Re: Extension of Time to Comply
with Violation Abatements.
Notice Violation No. N 80-1-13-2
Violation Nos. 1 & 2

Re: Southern Utah Fuel Company
Convulsion Canyon Mine
ACT/041/002
Sevier County, Utah

The purpose of this letter is to document our proposal to abate violations No. N 80-1-13-2, numbers 1 and 2.

SEDIMENTATION POND
AND APPURTENANCES

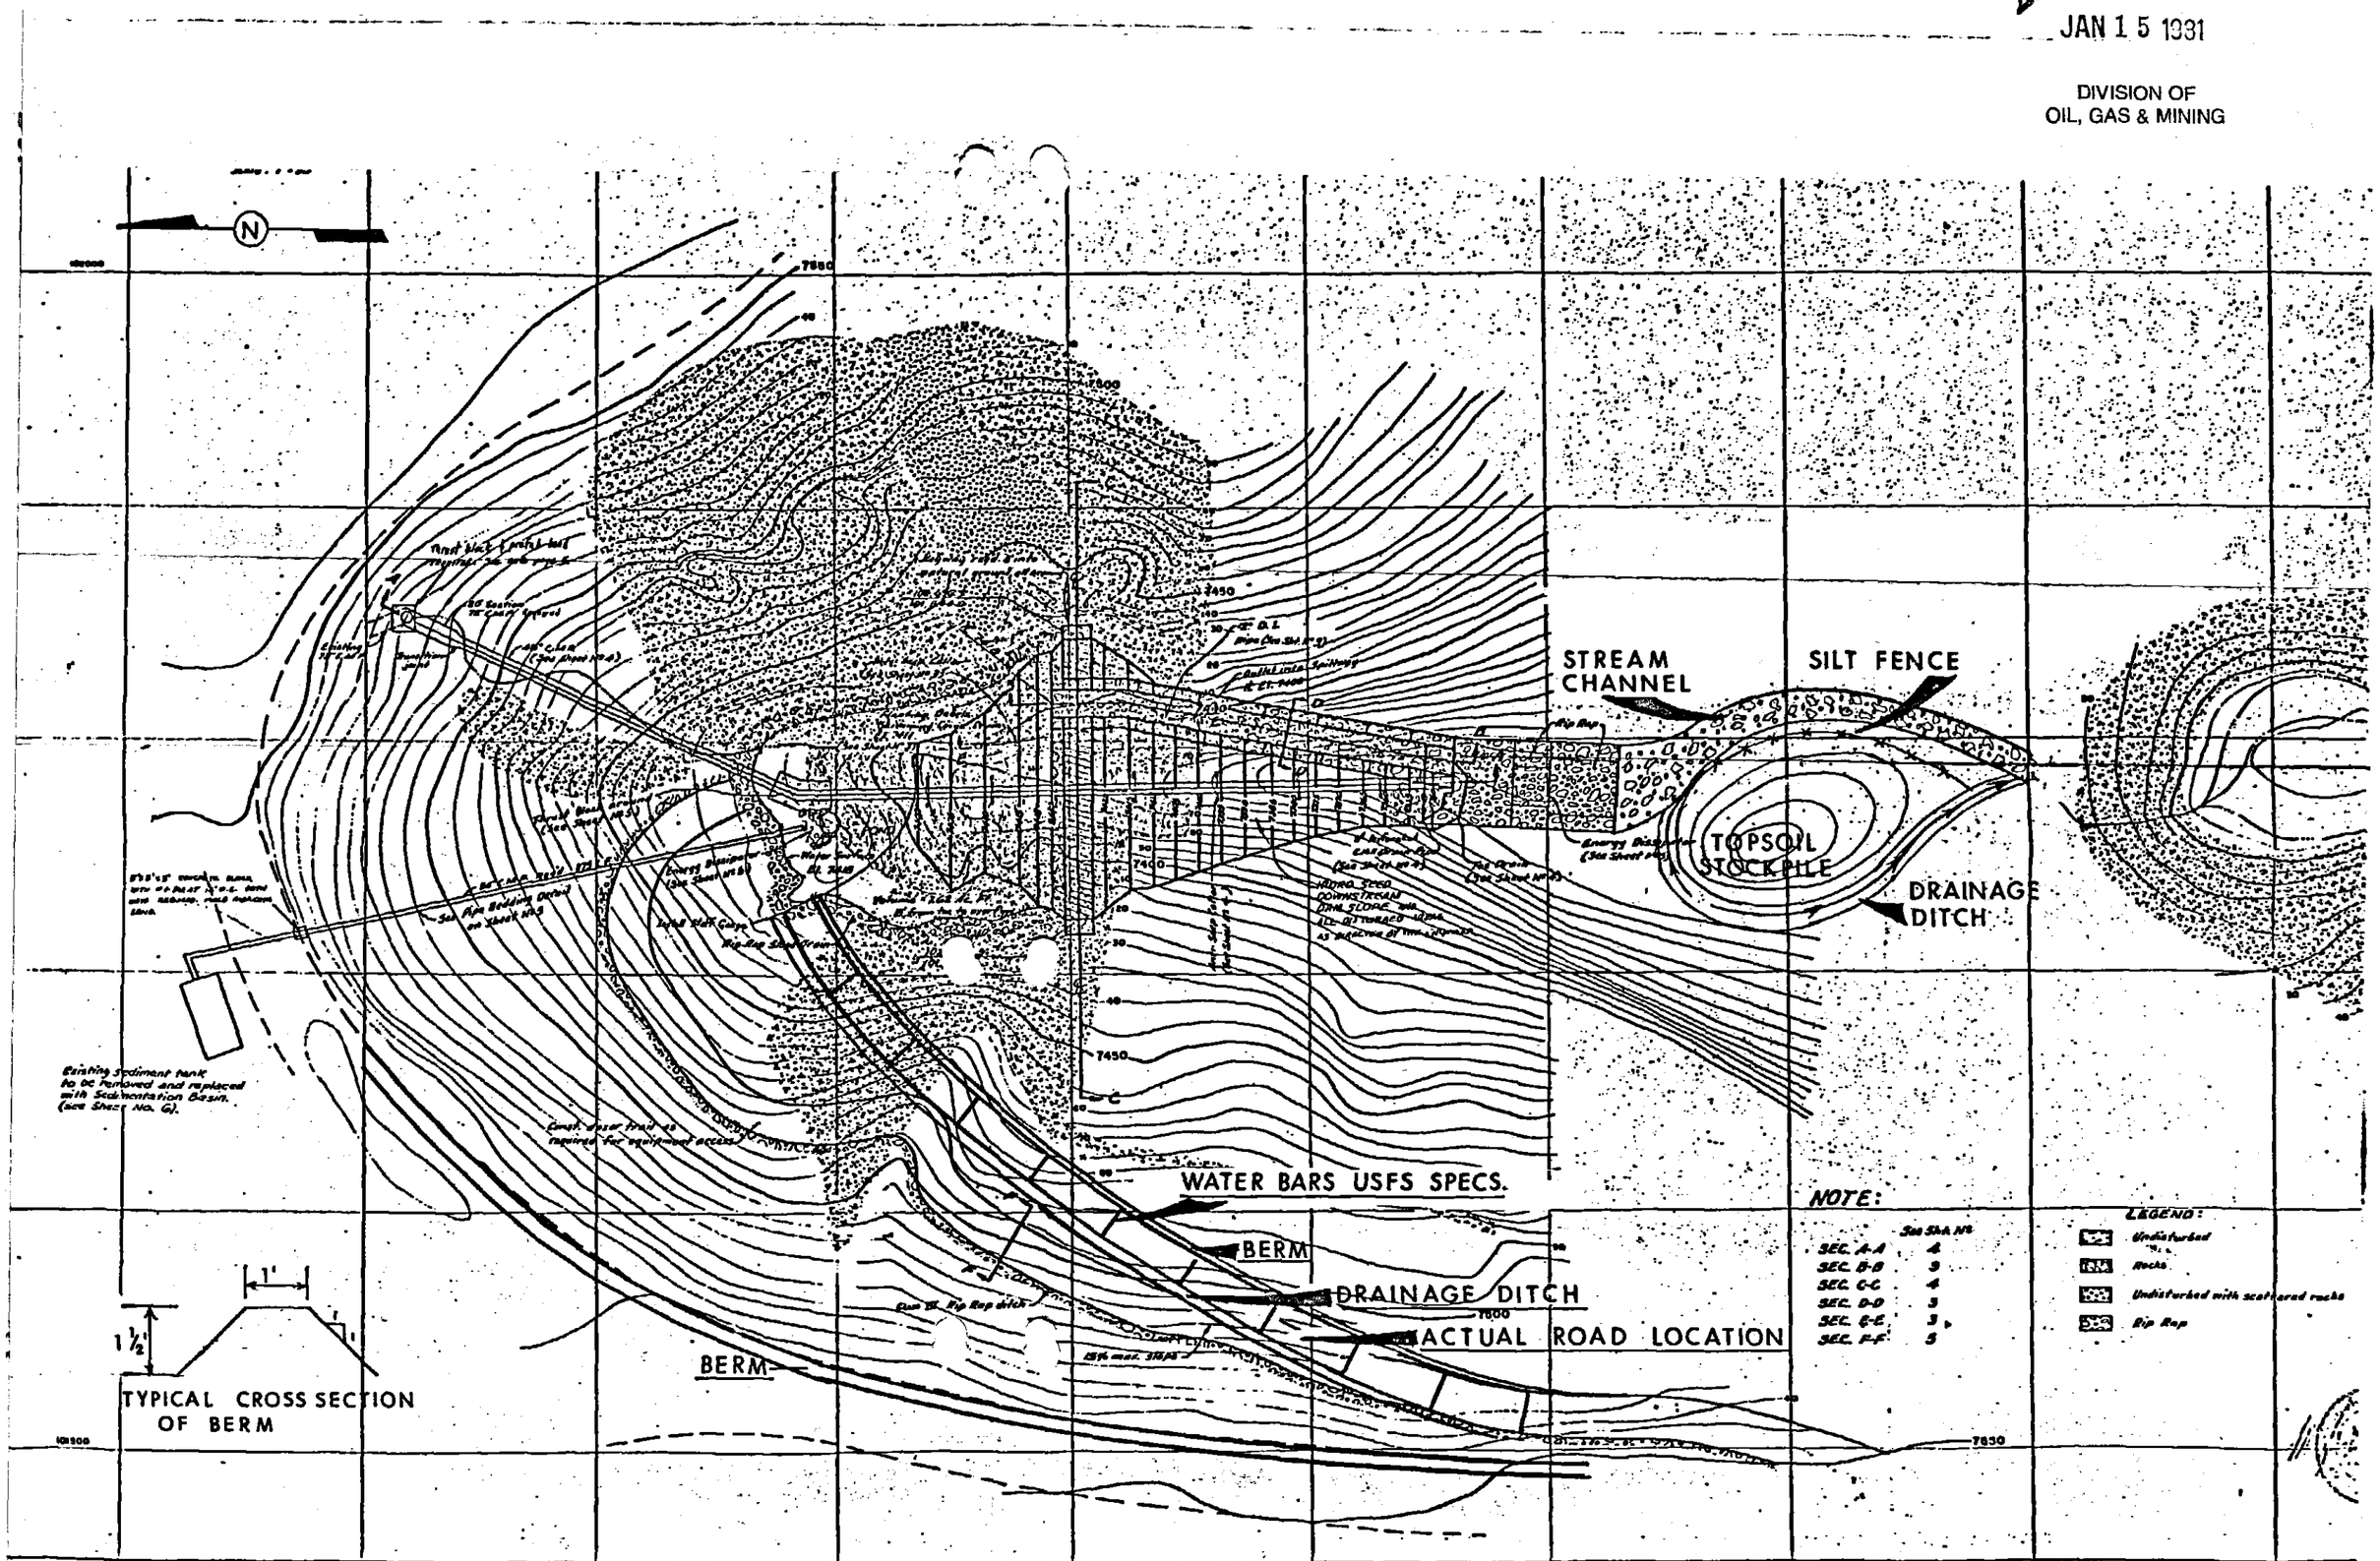
SUFCo is requesting a variance of Mc 717.14(a)(1) and c, Title 40-10-17c for the access road to the sedimentation pond. SUFCo is also requesting a modification of the road location as shown in Figure 1. The following summarizes the reasons for making these requests:

2. The road to the pond as shown in Figure 1 represents the only feasible access route.

5. Location of the road should be changed in order to avoid cutting into the loose fill material north of the sedimentation pond. Such a cut likely would have resulted in a very unstable situation on the face of the loose fill.

1. Drainage will be established by use of ditches, berms and water bars as shown in Figure 1. Erosion and excessive wet conditions on the cuts and side cast slopes will be minimized.

2. Figure 1 shows the proposed topsoil stockpile location. The stockpile will be protected from runoff by establishing drainage ditches around the stockpile. The toe of the stockpile will be stabilized with a silt fence. The stockpile will be seeded. The stream will be channeled away from the stockpile area. A sign will be placed on the stockpile designating the material as topsoil.
